# WEBSTER STREET AND HENRY LAWSON DRIVE, MILPERRA

## PRELIMINARY DESIGN ROAD SAFETY AUDIT

DOLTONE HOUSE

Project No: P1790

DATE: 29.08.2014  
APPROVED: JAR  
SCALE: 1:1000@A3  
DRAWING NO.: 14S1303000-01-01-P1

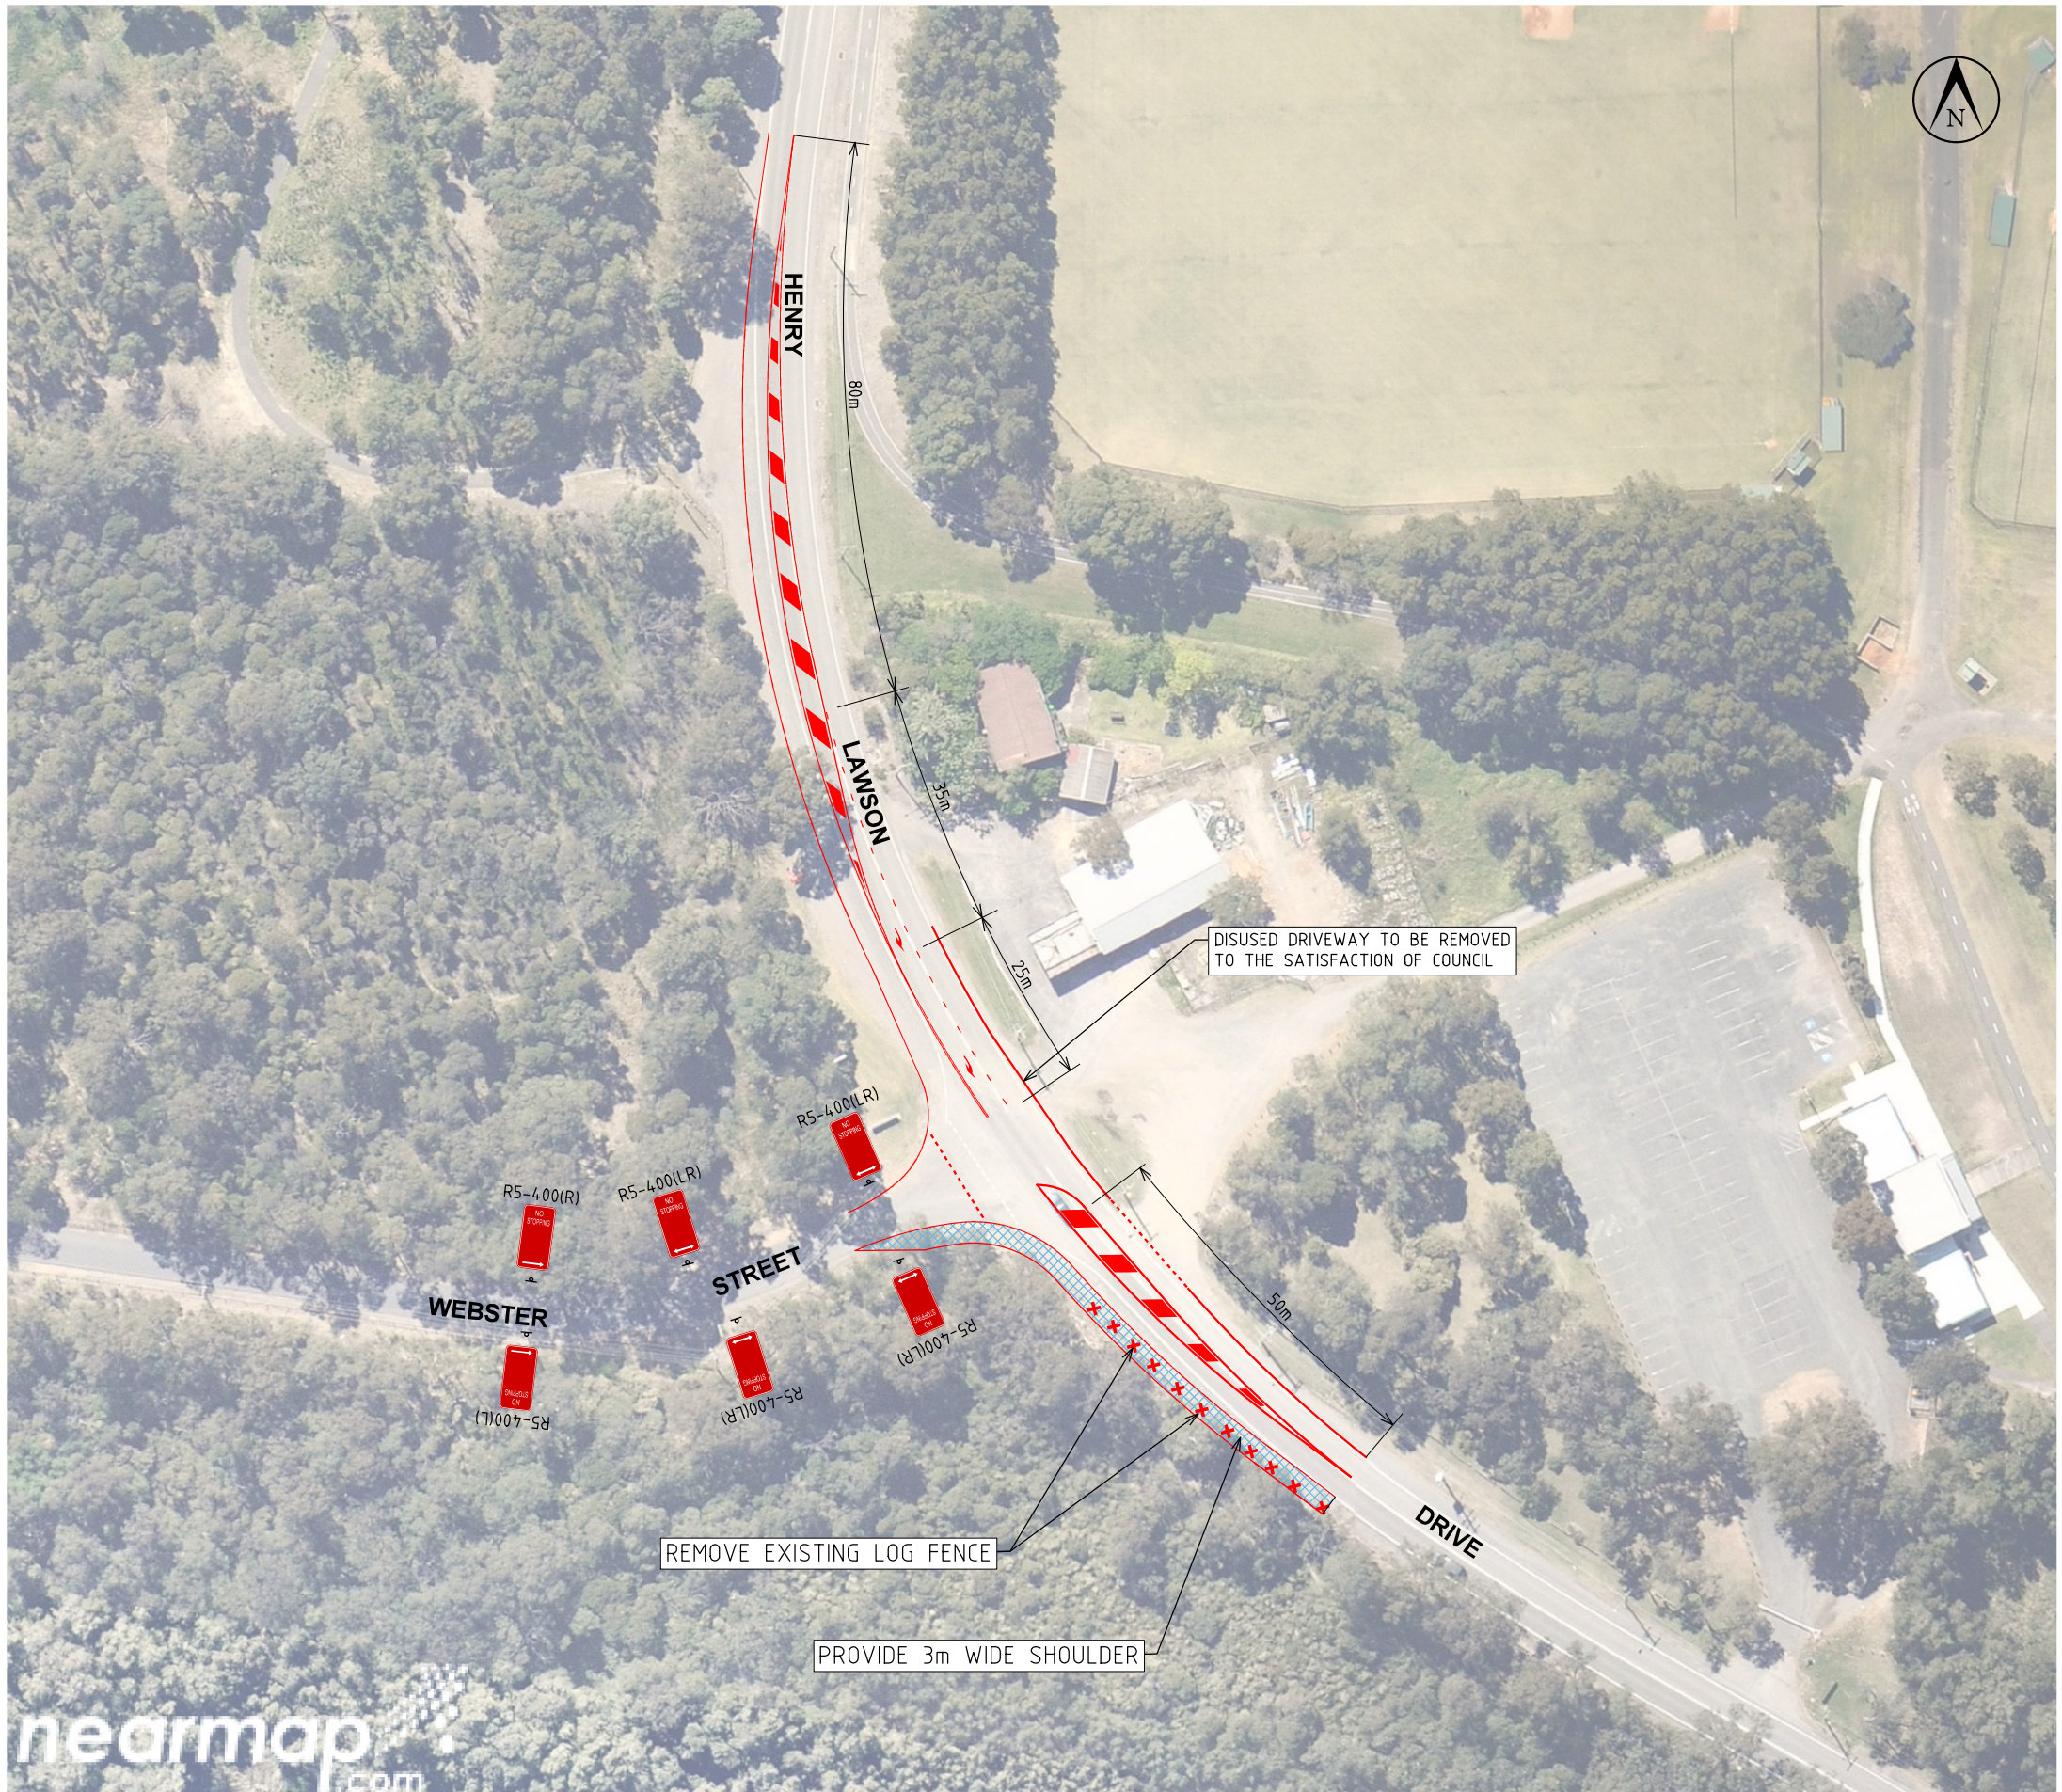
Item	Plan No.	Risk Priority	Issues	Site Illustration	Audit Response
1	1	High	<p>The widening of the road will make the travel lane closer to a mature tree. It is estimated that it will be located some 3m from the nearest travel lane on the outside of a horizontal curve.</p> <p>There is a risk that an errant vehicle could collide with the tree.</p>	 	<p>The location of the tree relative to the nearest travel lane shall be considered during detail design of the intersection.</p> <p>Should the location of the tree be within the 3m zone then mitigation measures such as barrier controls or tree removal shall be considered.</p>
2	1	Medium	<p>There is a batter slope located on the outside of the bend on the eastern approach to the intersection. The slope will be unprotected and there is a risk that an errant vehicle may overturn.</p>		<p>Batter design and associated barrier protection shall be considered during detail design of the intersection.</p>

Item	Plan No.	Risk Priority	Issues	Site Illustration	Audit Response
3		High	The plan indicates that the log fence will be removed only part way to the intersection as indicated by the x's . The remaining log fence near the intersection is located on the outside of a horizontal curve and would be a hazard for errant vehicles that may collide head on into the fence.	 	It is recommended that the extent of the log fence removal be extended around the curve into Webster Street.
4		Low	There is an unprotected drainage culvert located on the Webster Street approach to the intersection. An errant vehicle could strike the concrete structure. Further, there is poor delineation of the object with an unreflective white post that would be hard to see in low light conditions.		Guide posts and reflectors to be installed to delineate this object. It is noted that these works are required to address an existing situation and should be undertaken with or without approval of the Deepwater Motor Boat Club DA.

Item	Plan No.	Risk Priority	Issues	Site Illustration	Audit Response
5		Medium	<p>The exiting road has a super elevation on the curve. At this stage in the design it is unclear whether the super elevation will be maintained or a crown introduced in the road.</p> <p>(i) If the super elevation is maintained for widened section then the road shoulder will slope away from the road reducing the chance of recovery or directing vehicles toward road side objects.</p> <p>(ii) If not maintained then vehicles will have less grip while negotiating the turn.</p>		<p>Super elevation and in particular the associated issues identified in this audit shall be considered during detail design of the intersection.</p>

Item	Plan No.	Risk Priority	Issues	Site Illustration	Audit Response
6		High	<p>Sight distance to the intersection is restricted by vegetation on inside of the curve. There is a potential for a vehicle on the main road to collide with a vehicle turning right from Webster street.</p> <p>Austrroads Guide to Road Design part 4A recommends a Safe Intersection Sight Distance of 123m. We estimate that from the existing hold line there is some 95m. From the future hold line sight distance will be 110m. Removing the vegetation would provide adequate sight distance.</p>		<p>It is recommended that the vegetation which is located within the road reserve be trimmed / removed such as to provide appropriate sight distances.</p> <p>It is noted that these works are required to address an existing situation and should be undertaken with or without approval of the Deepwater Motor Boat Club DA.</p>
